Access Compliance Report

Public Rights-of-Way

Intersection ID: 45303	Main Street: CINDY_CREEK_LN	Cross Street: CINDY_WOODS_LN	Location: NW
ADA ID: C6E93646FB52	Ramp Type: PerpDiag	Initial Pass/Fail: Fail	Overall Compliance: No
Severity Score: 42.5			
Codes/Mitigation Info/Possible Solution		Field Measurements/Component Compliance

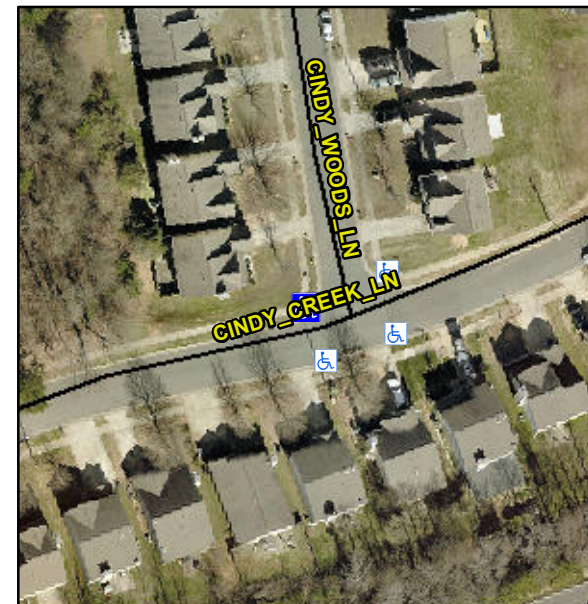
Not Found, R304.5.1, R304.5.3

Compliance	Description	Data	Compliance	Description	Data
N/A	Ramp Length (in)	52.0	Yes	Ramp Slope (%)	5.8
No	Ramp Width (in)	34.0	No	Ramp XSlope (%)	7.0
N/A	Flare Type LT	N/A	N/A	Flare Type RT	N/A
N/A	Flare Slope LT (%)	N/A	N/A	Flare Slope RT (%)	N/A
N/A	Flare Traversable LT?	N/A	N/A	Flare Traversable RT?	N/A
N/A	Landing Length (in)	N/A	N/A	DWS Provided?	N/A
N/A	Landing Width (in)	N/A	N/A	DWS Contrast?	N/A
N/A	Landing Slope (%)	N/A	N/A	DWS Length (in)	N/A
N/A	Landing X Slope (%)	N/A	N/A	DWS Full Width?	N/A
N/A	Landing Curb? (Y/N)	N/A	N/A	DWS Offset (in)	N/A
N/A	Shared Landing?	N/A			
N/A	Gutter Ponding?	N/A	N/A	Gutter Slope (%)	N/A
N/A	Gutter Lip Ht (in)	N/A	N/A	Gutter X Slope (%)	N/A
N/A	Painted X Walk1?	No	N/A	Painted X Walk2?	No
	X Walk 1 Direction	To S		X Walk 2 Direction	To E
N/A	X Walk 1 Width (in)	N/A	N/A	X Walk 2 Width (in)	N/A
	X Walk 1 Slope (%)	0.7		X Walk 2 Slope (%)	5.2
	X Walk 1 X Slope (%)	5.4		X Walk 2 X Slope (%)	0.5

Remove & Replace Curb Ramp With Two New Directional Ramps or Equivalent.
